# Access Compliance Report

## Public Rights-of-Way

### (Curb Ramps)

| Intersection ID: 3595                   | Main Street: CLAIBORNE_WOODS_RD | Cross Street: TARPAN_CT                 | Location:              | W                    |

| ADA ID: 9214404155F4                    | Ramp Type: Perp                 | Initial Pass/Fail: Fail                 | Overall Compliance: No | Severity Score: 1.25 |

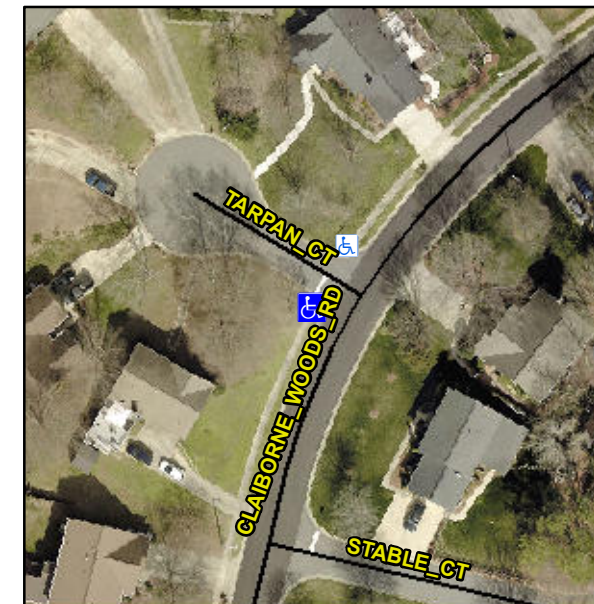
**N/A**

**Not Found, R304.5.3**

| Compliance | Description           | Data  | Compliance | Description                 | Data |
|------------|-----------------------|-------|------------|-----------------------------|------|
| Yes        | Ramp Width (in)       | 48.0  | No         | Ramp XSlope (%)             | 3.8  |

**Remove & Replace Entire Ramp.**
